City of Coconut Creek

InterOffice Memorandum

Subject: **PNC Bank @ Caligo Crossing**
Farris Corner Plat

Subject: **PNC BRANCH BANK**
Change of Plan

Exterior Elevation - Front Side
©2010 Gensler

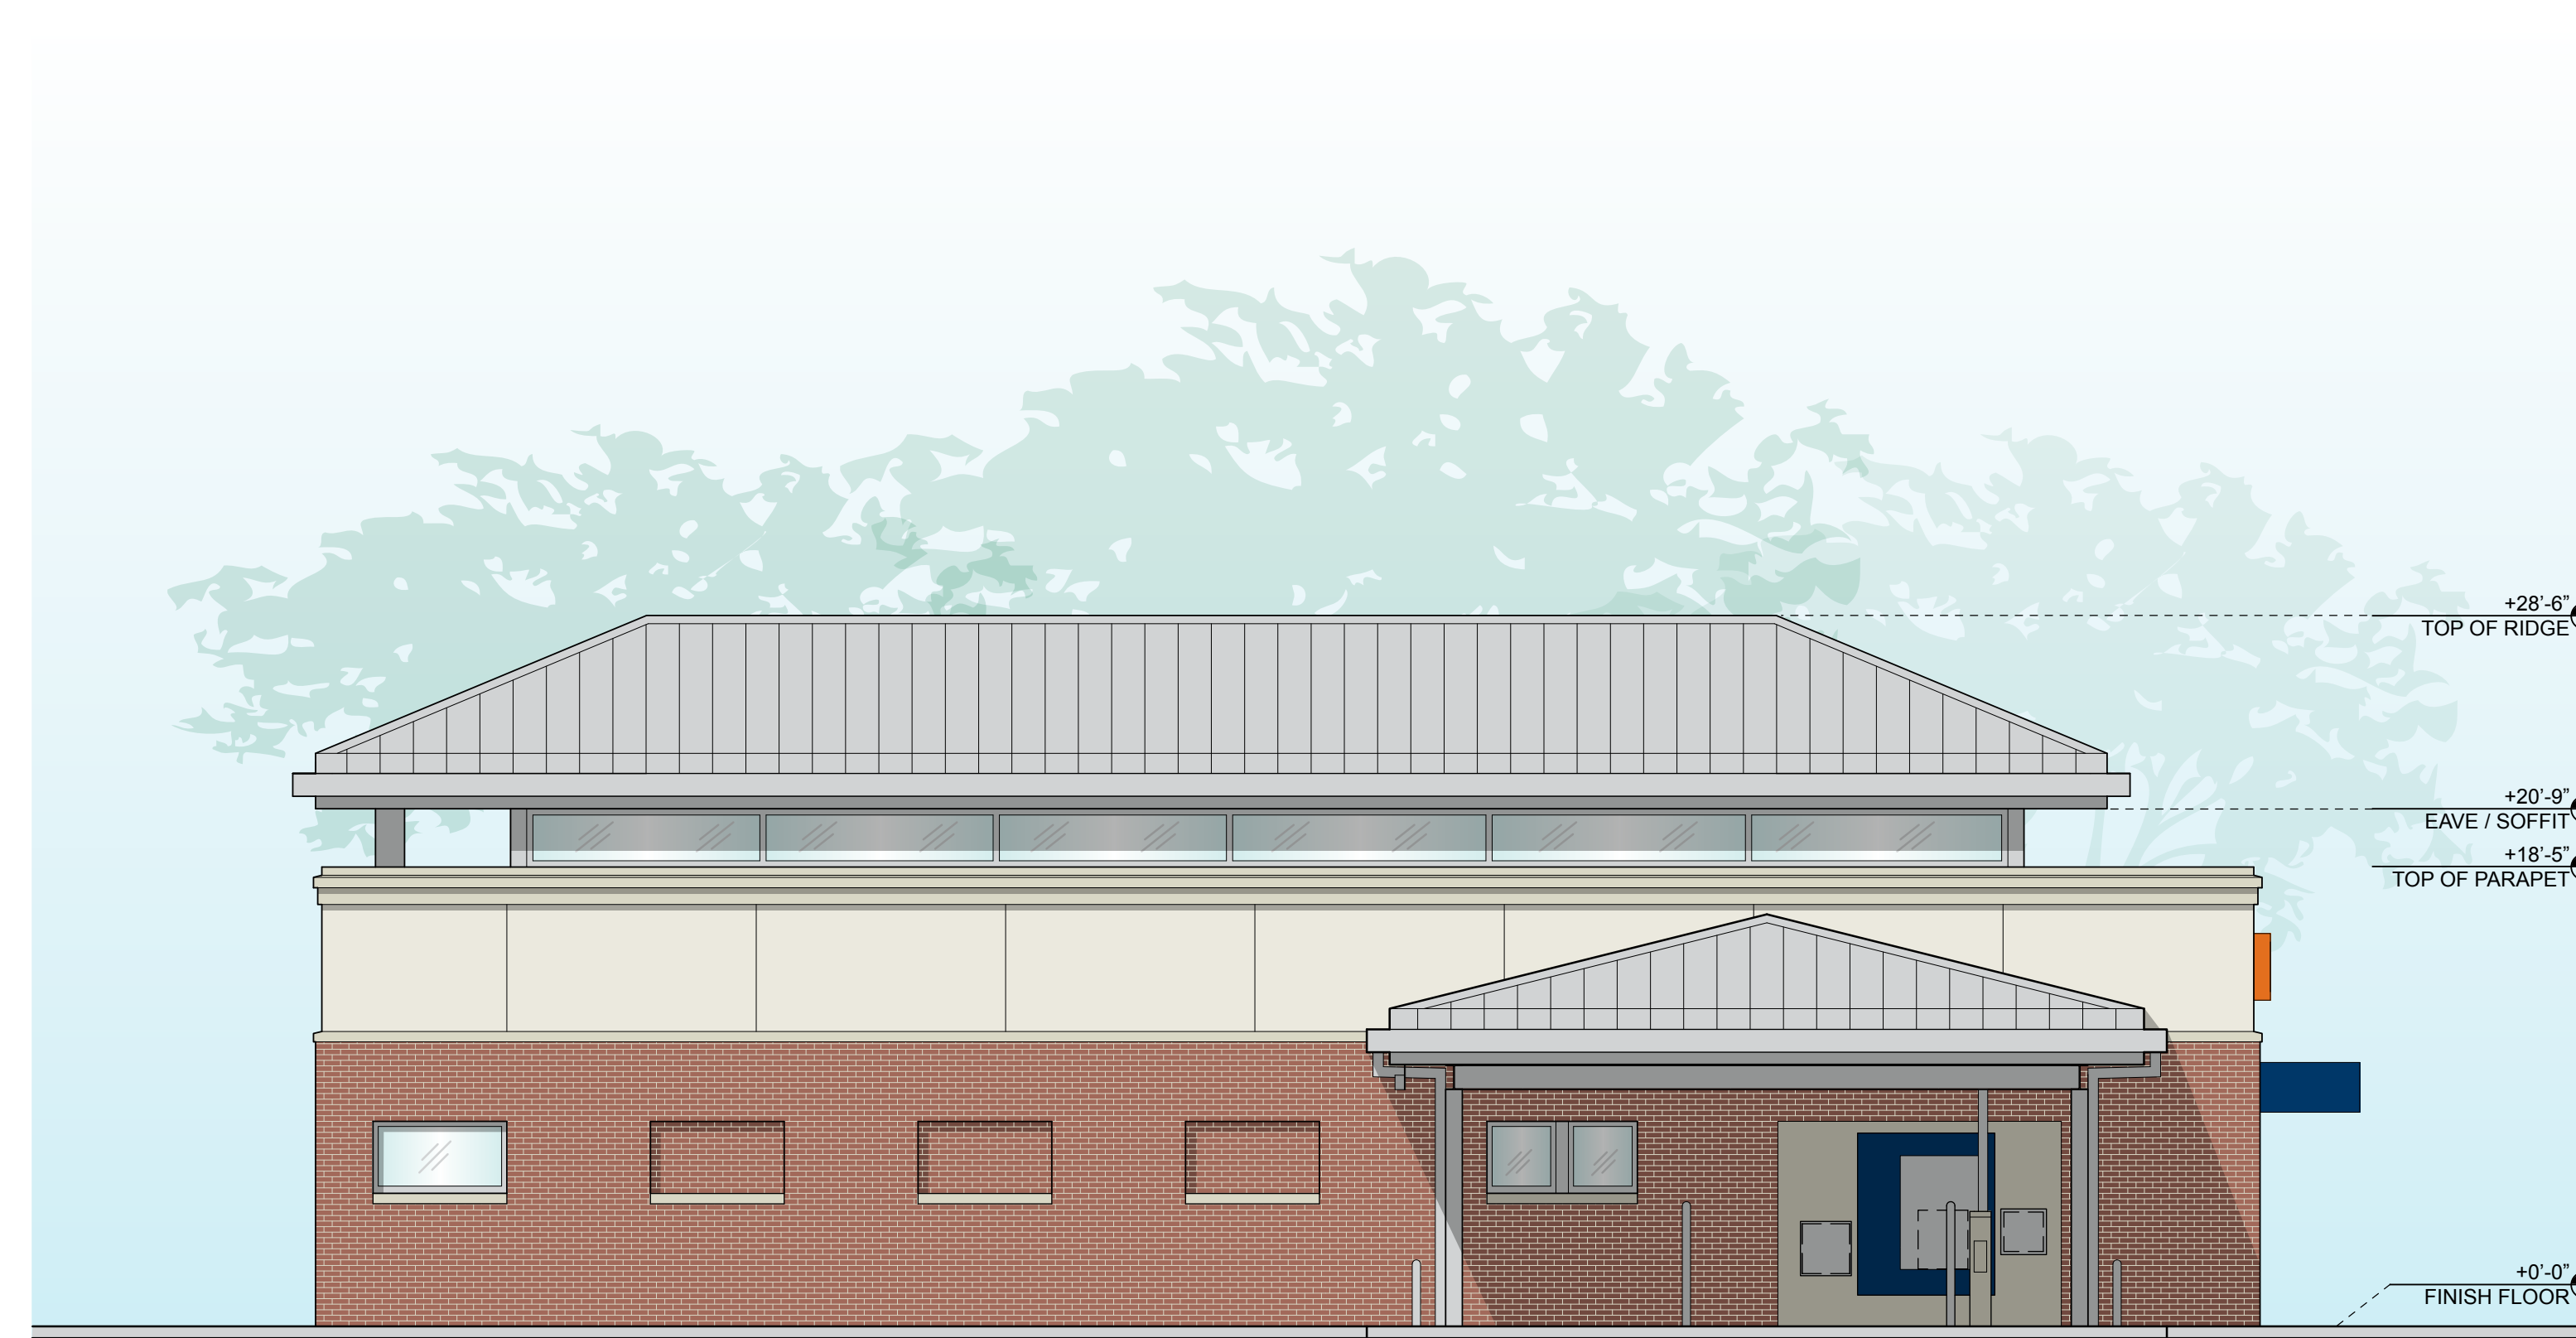
1) High Roof Design: Change from the proposed "wing" roof shape to a more traditional "hip" roof design. Top of ridge raised to 28'-6" above slab. Truss drawings will be resubmitted to show new roof design.

2) Parapet Heights: The parapets on both sides of the building have been raised to provide full screening of roof top equipment. Heights are shown on elevations. The previously proposed equipment screen will be eliminated.

3) Exterior Wall Materials: Instead of an all brick facade, the new proposed design offers a stucco band at the top of the wall with brick below as shown on the exterior materials palette. Color and texture of brick below has not been changed from previously approved. The color of the storefront framing and miscellaneous metal trim has not been changed from the silver grey color. The material for the pitched roofs has not been changed from silver standing metal seam roof. Minor changes in wall articulation are proposed as well such as a precast concrete band at the transition between the brick and stucco as well as a more heavily articulated cornice as shown in the submitted elevations and rendering.

5) Entry Canopy: Entry canopy shape changed from pitched roof to larger flat entry roof. The intent of the larger flat roof is to provide a more gracious "porch" area at the entry and act as a refuge from rain

Exterior Elevation - Drive-Thru Side
©2010 Gensler

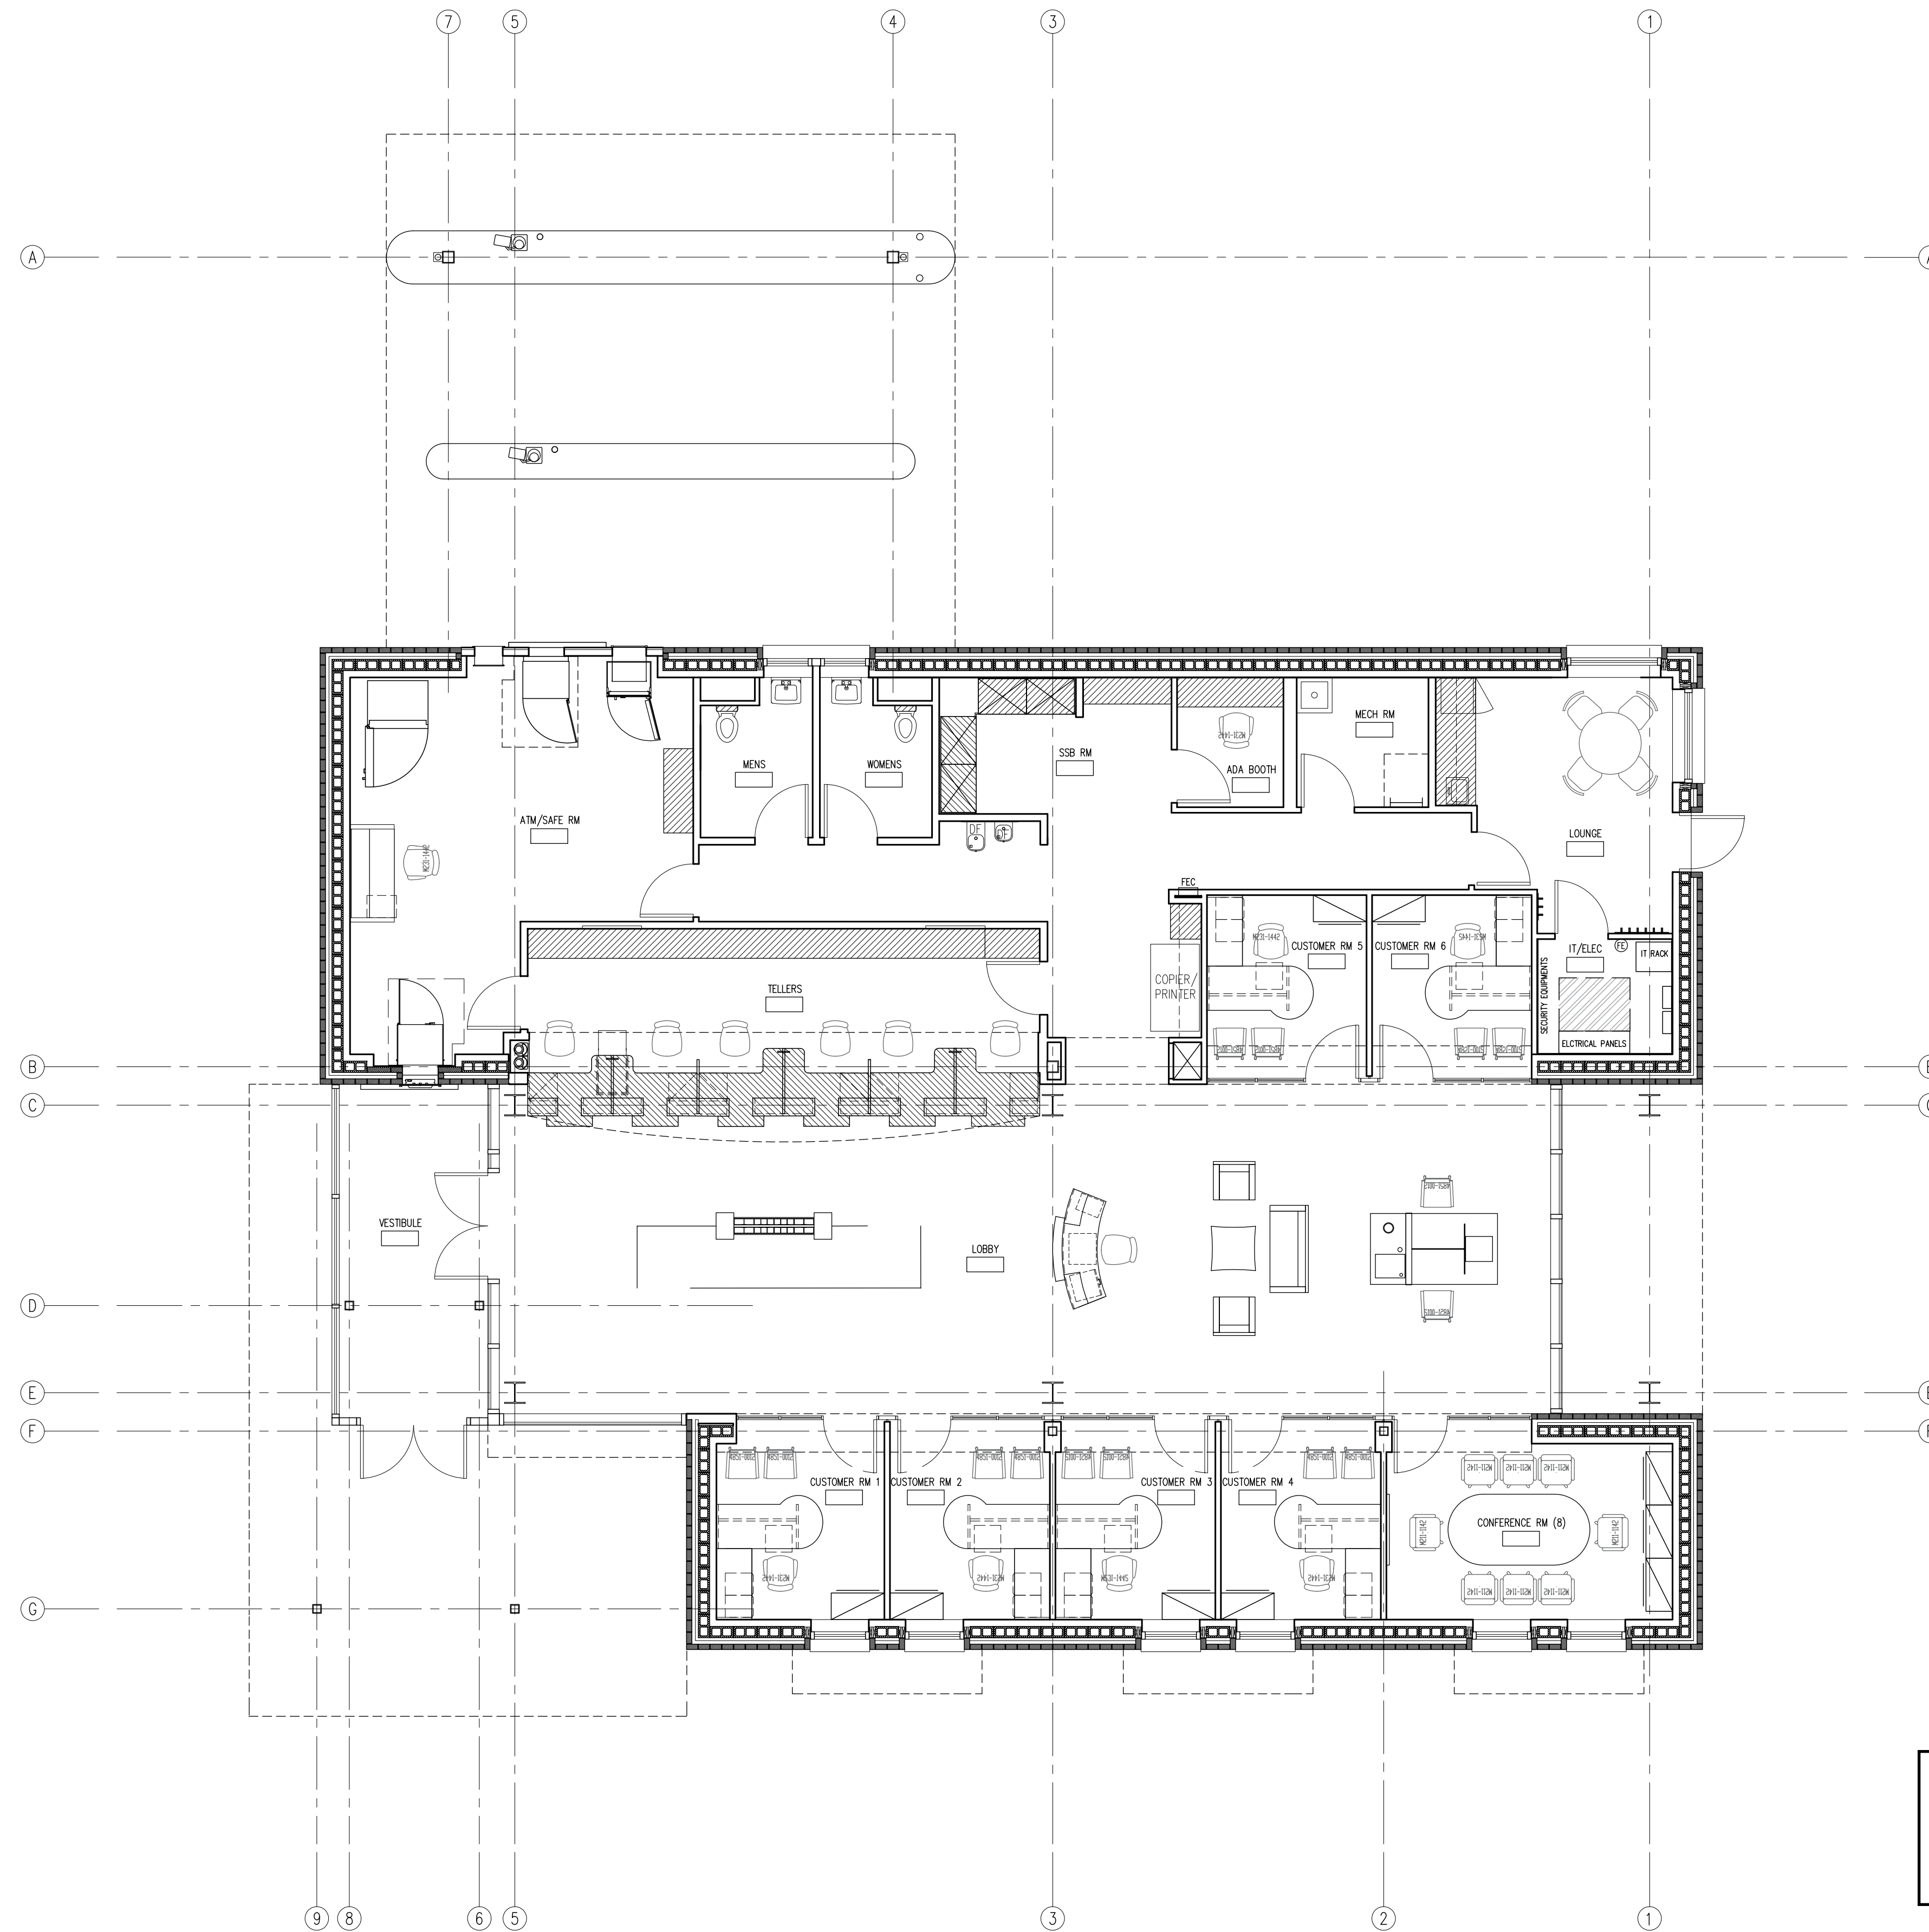
4) Drive Through Canopy Roof: Shape of roof changed to match hip design of high roof.

6) Drive Thru Elevation: Three brick relief panels have been added to the wall in lieu of the tan colored brick band previously approved.
